ADDENDUM No 1: Changes and Revisions

ORANGE COUNTY BID No 367-OC5429

EFLAND COMMUNITY CENTER RENOVATIONS

LIFE SAFETY
PLANS

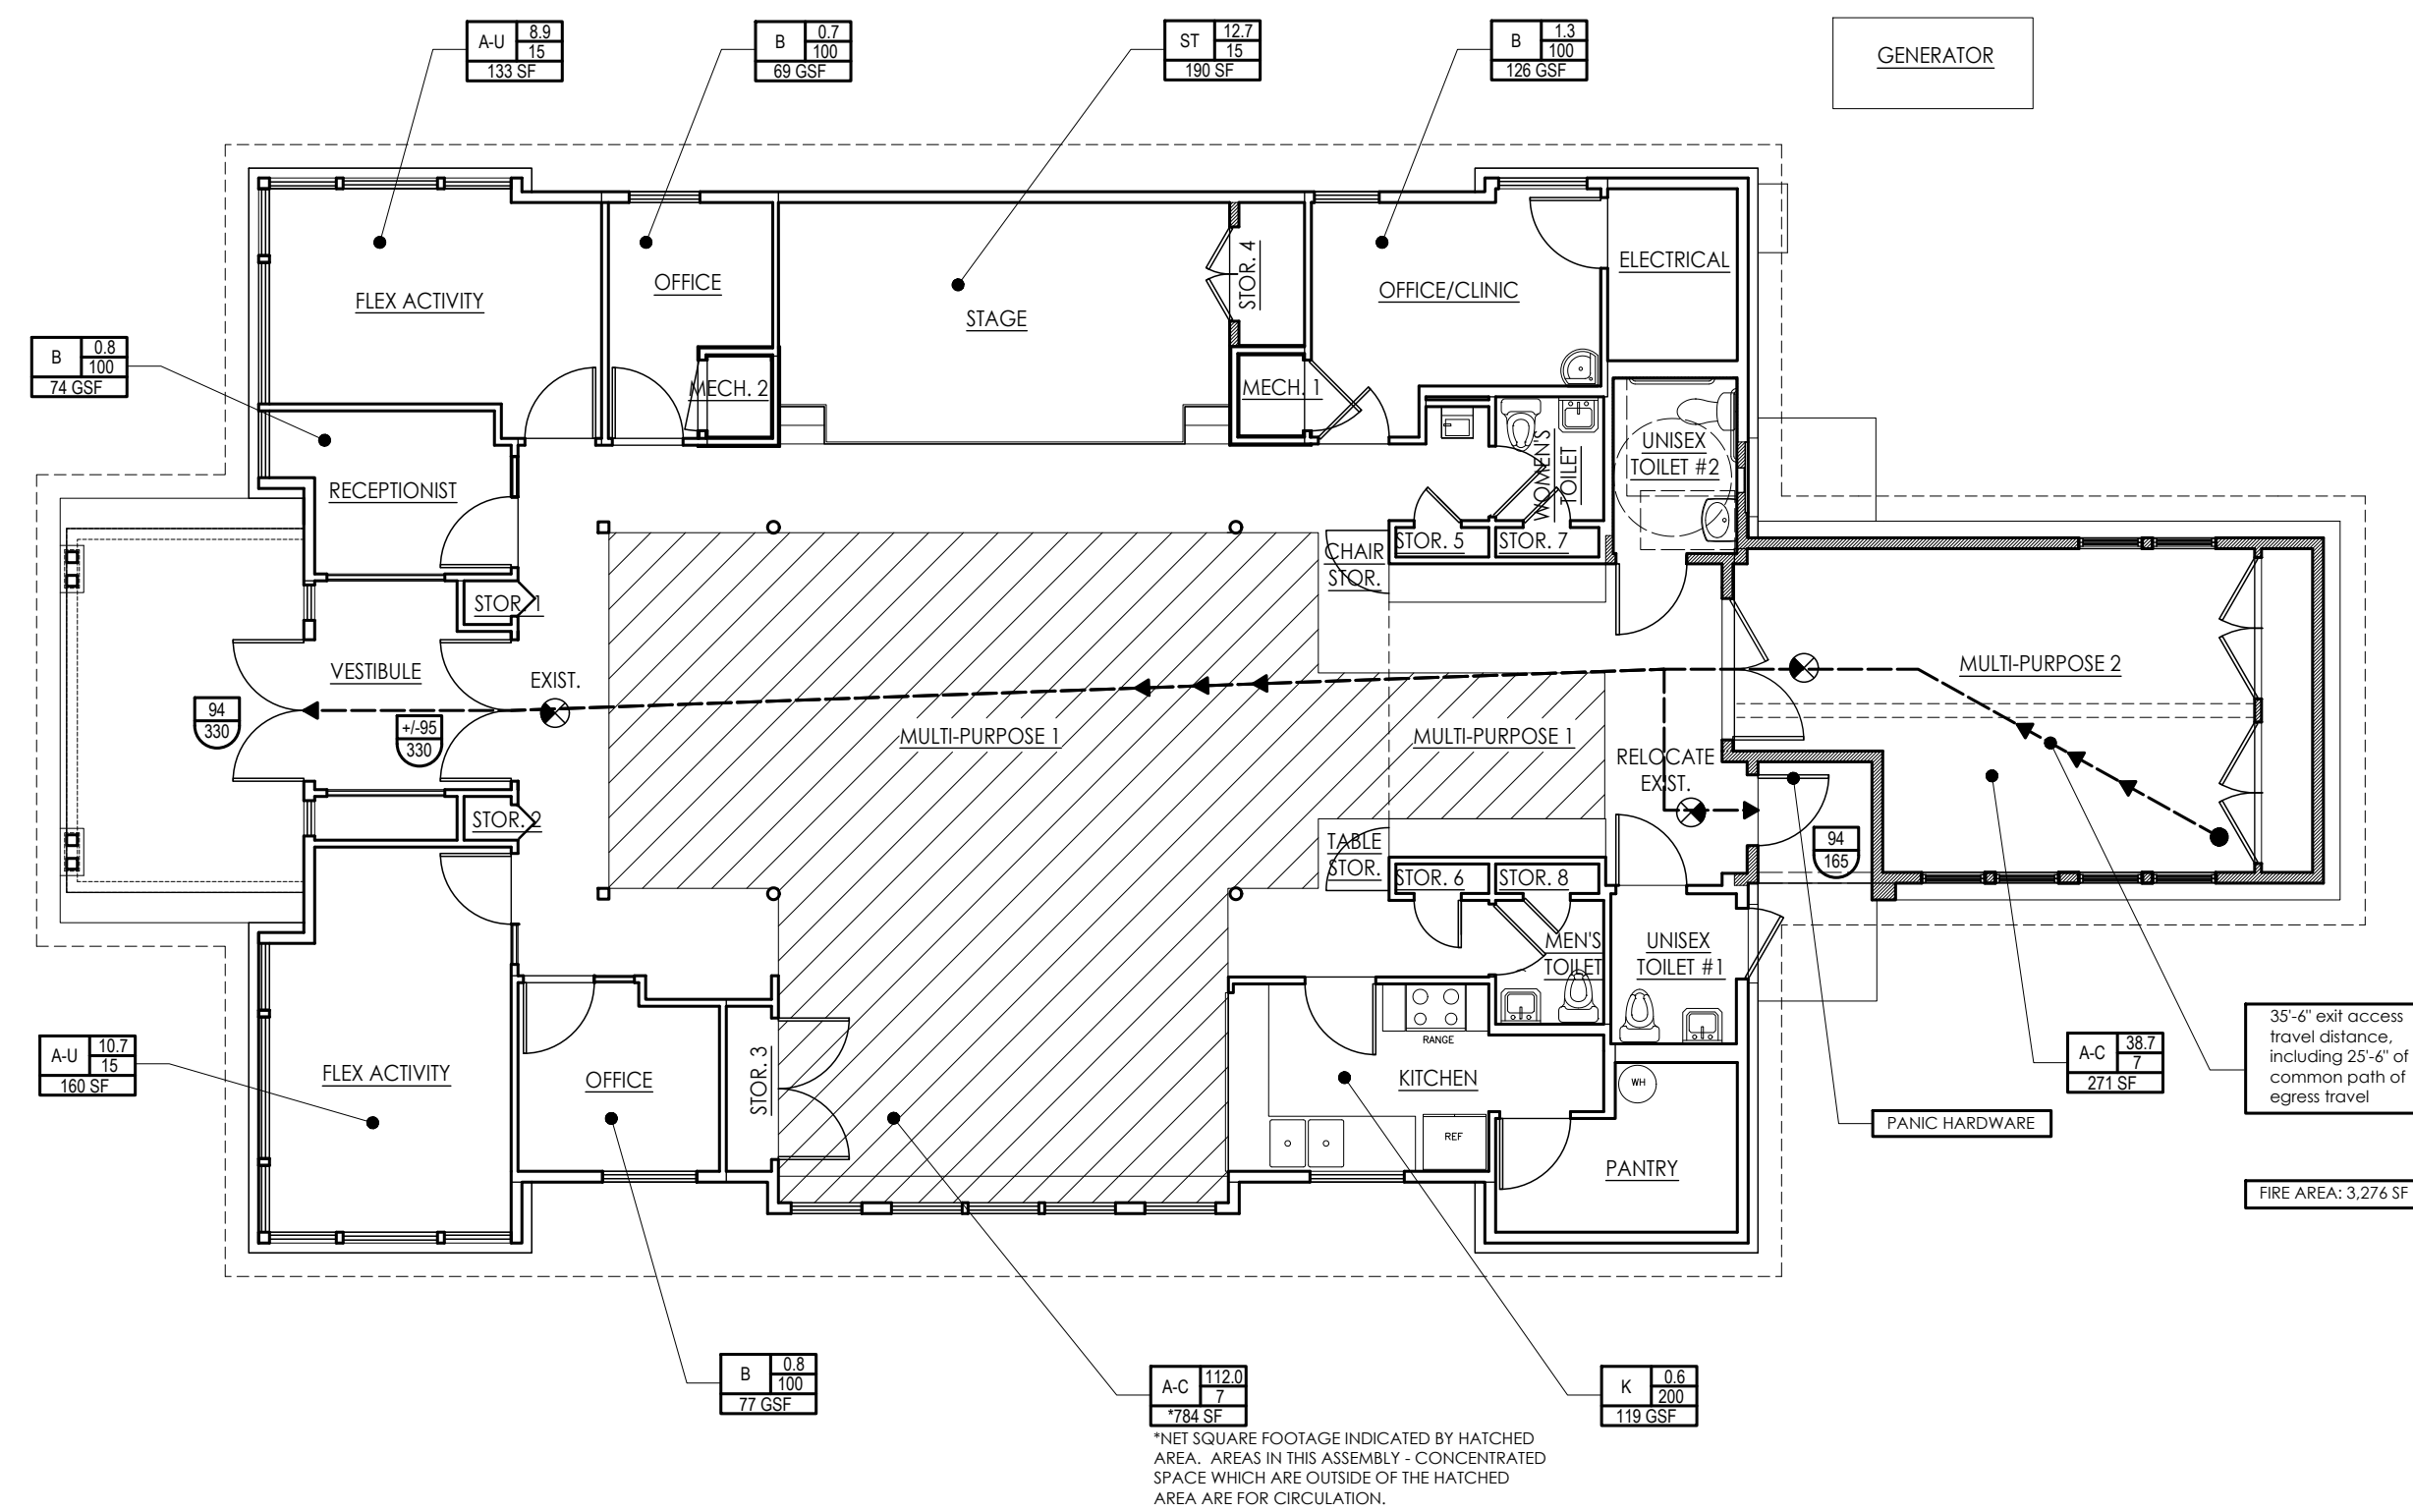
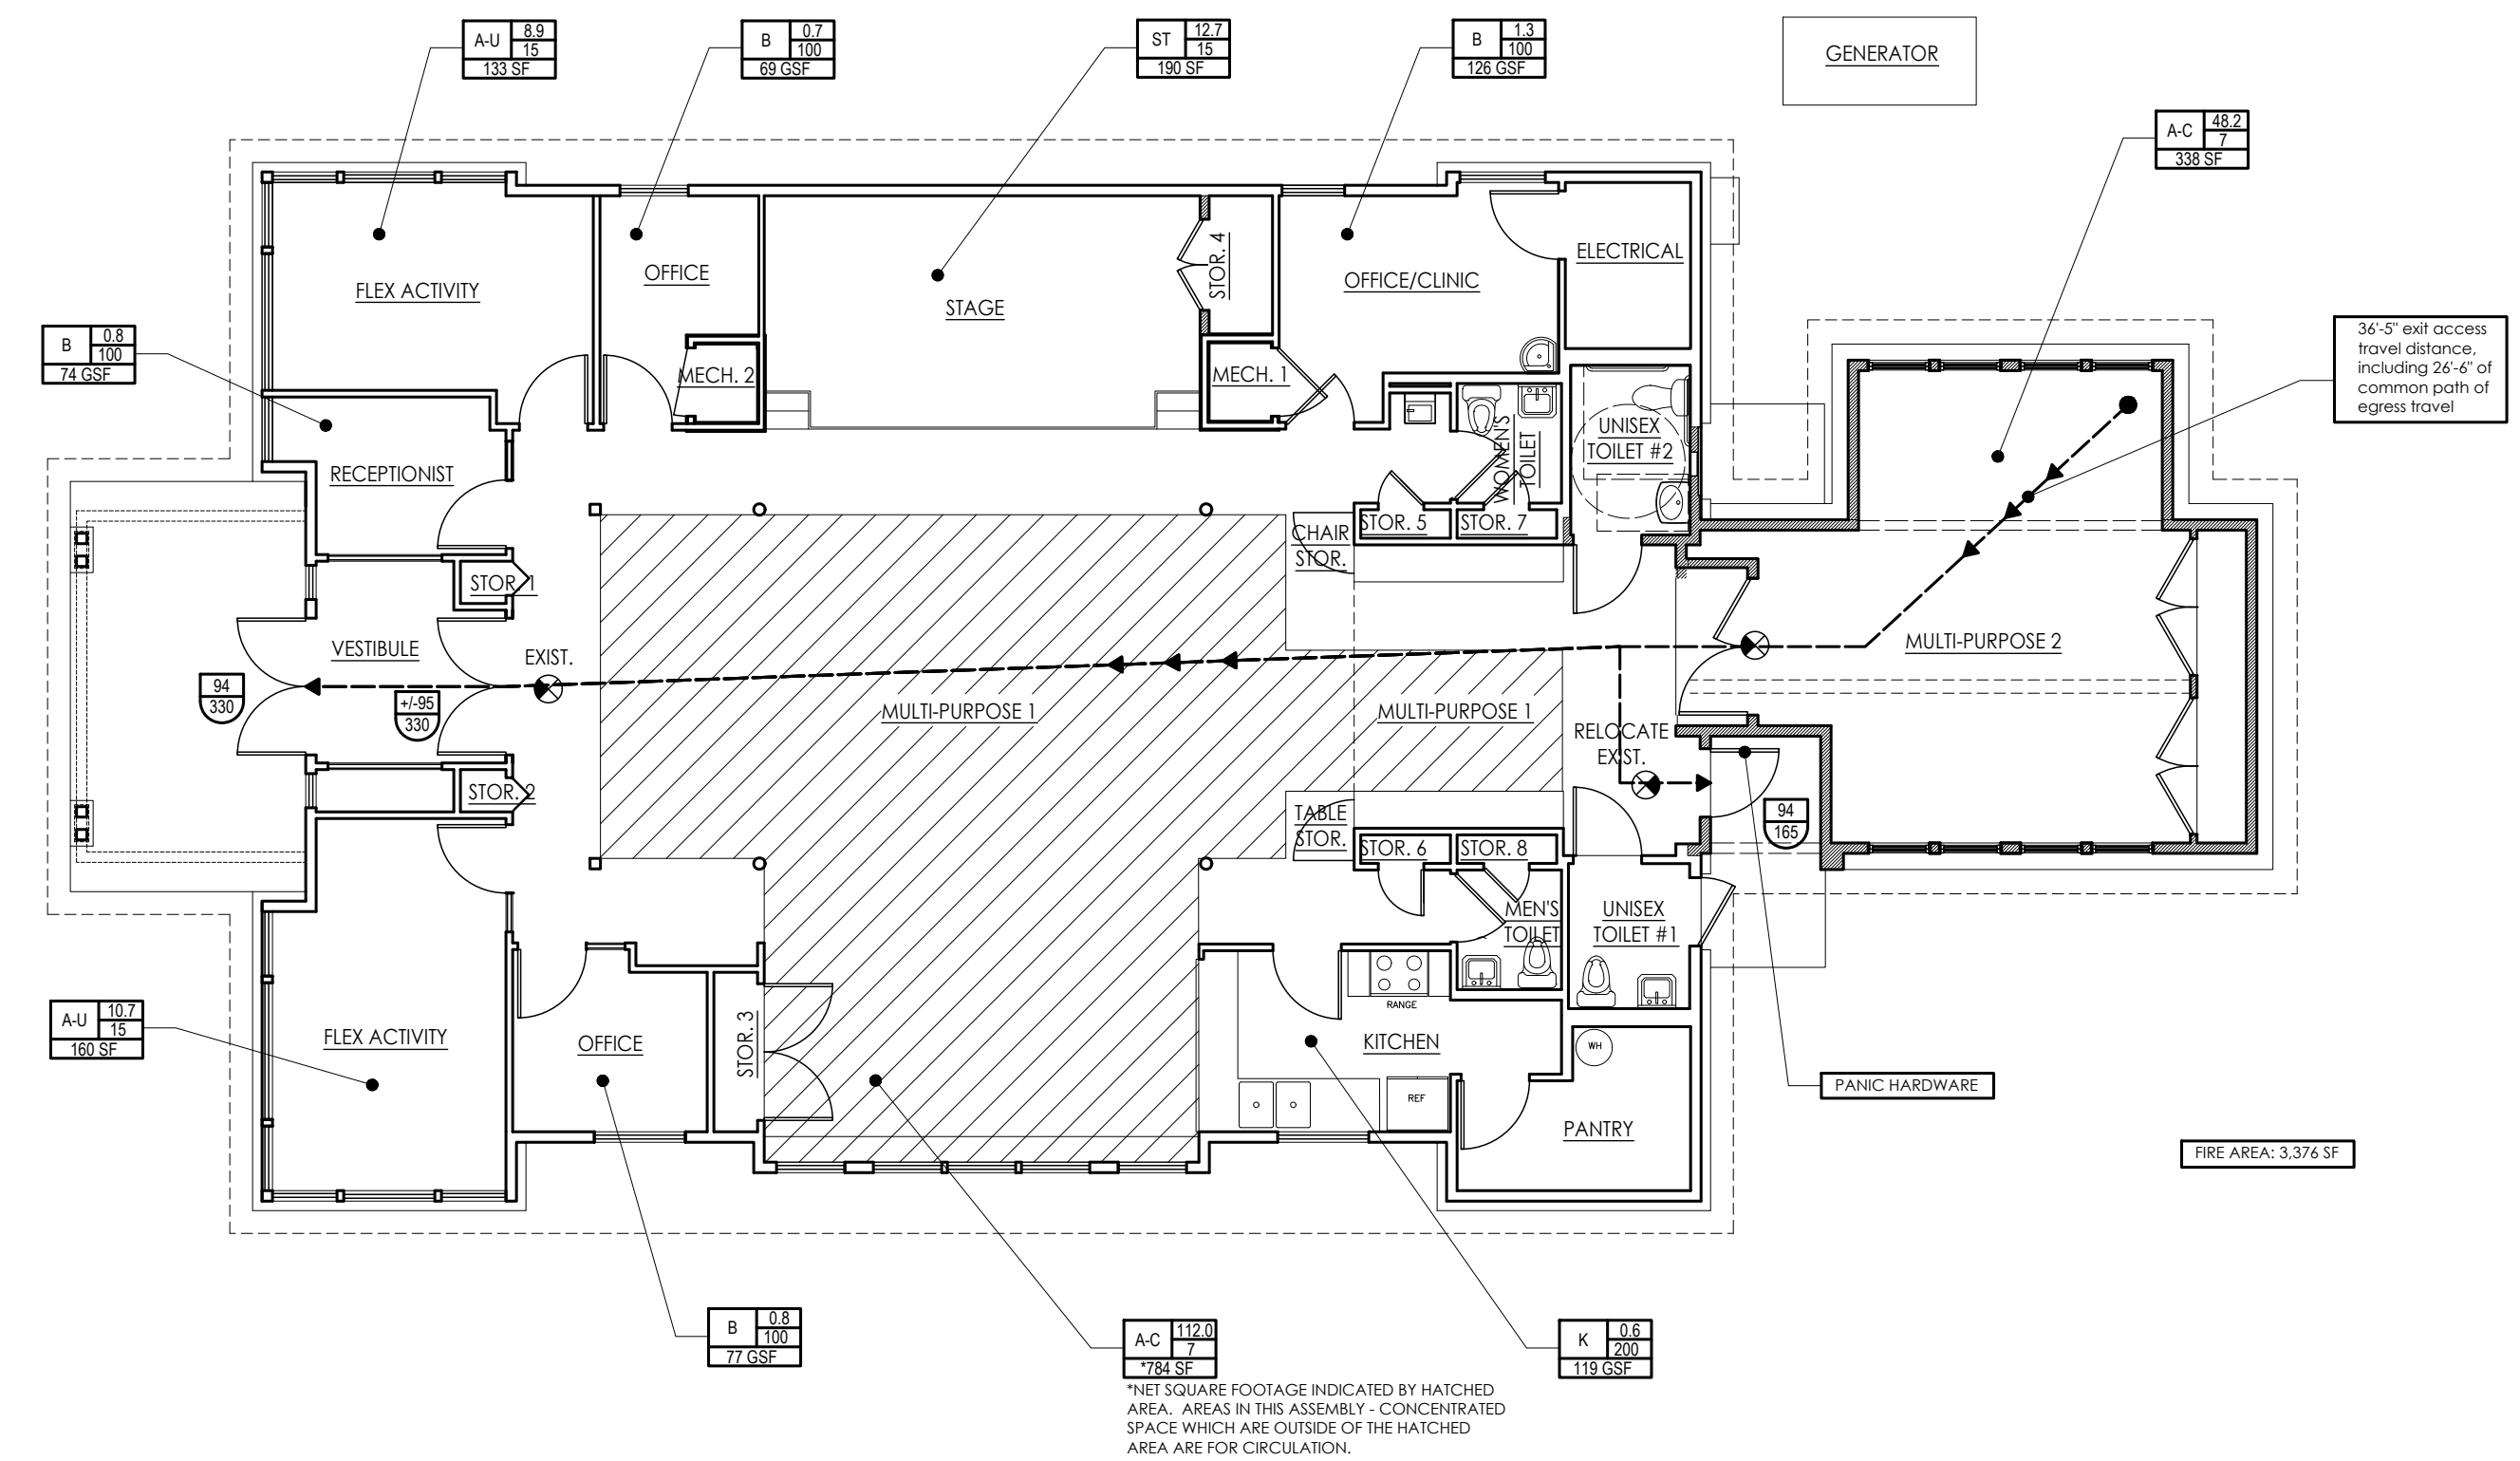
- *Sheet A1. The life safety plans have been revised to show a new toilet room layout. Revisions have not been clouded.
- *Sheet A3 has been revised to show new demolition scope related to the new toilet room layout. Revisions have been clouded.

FLOOR PLAN
1/4" = 1'-0"

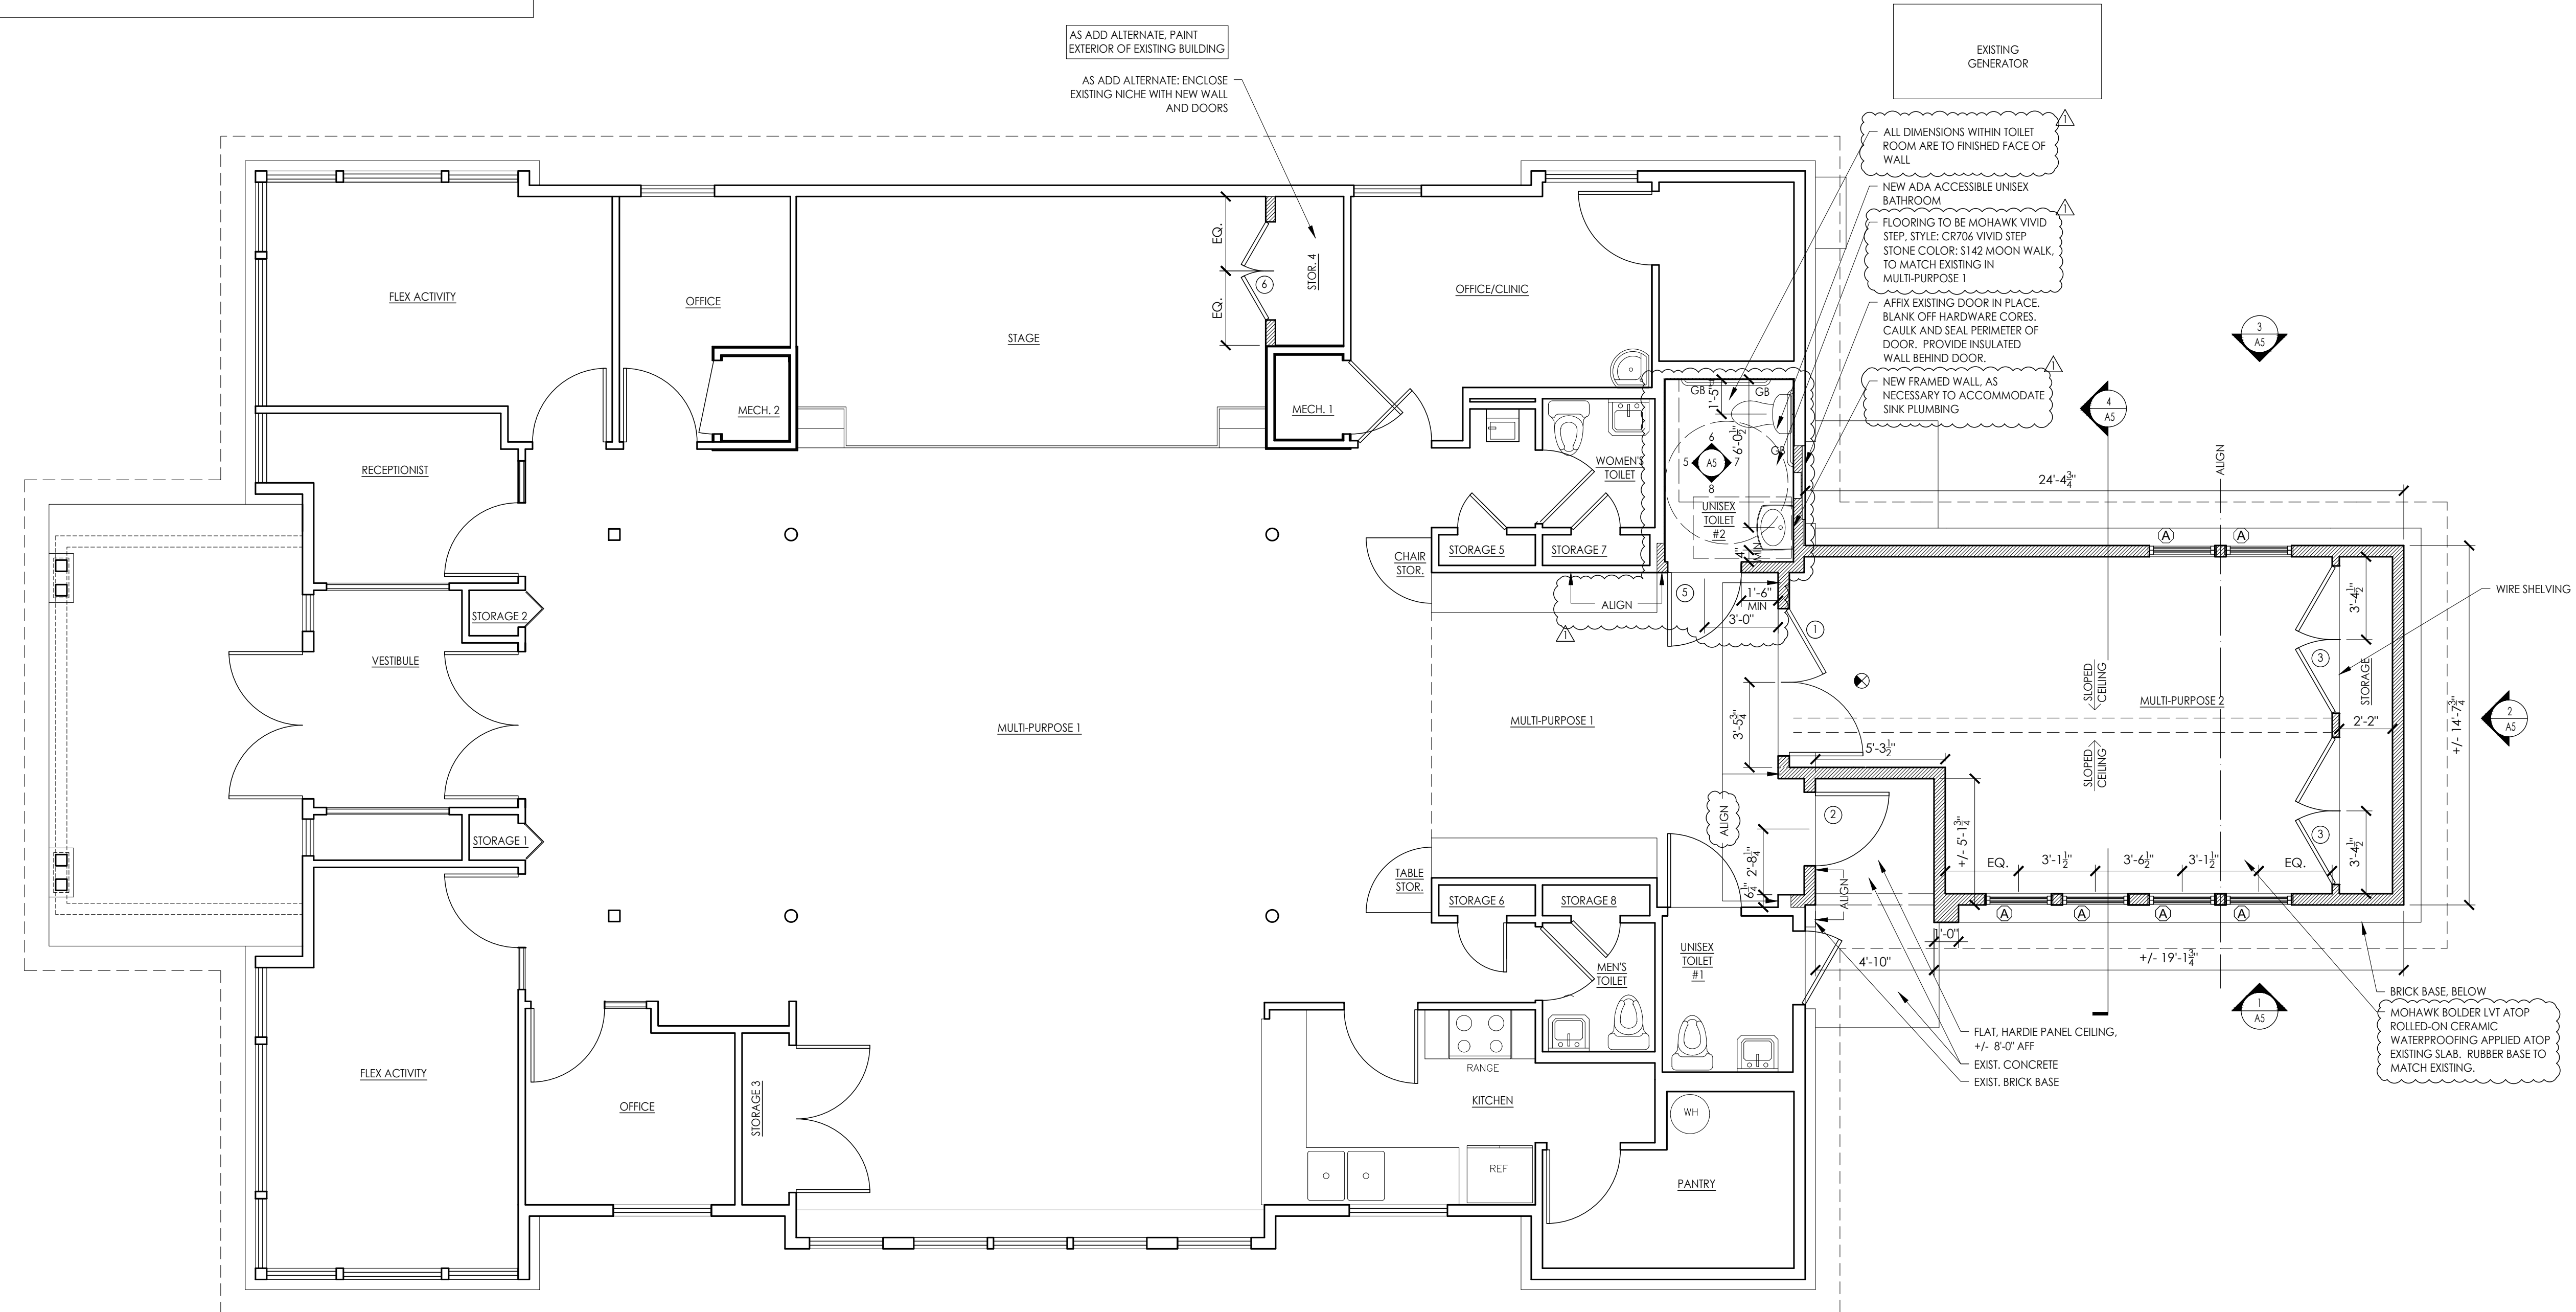
- *Sheet A4 has been revised to show a new toilet room layout and new notes associated with the new layout. A note regarding flooring in Multipurpose 2 and in its associated storage closet has been revised. Revisions have been clouded.
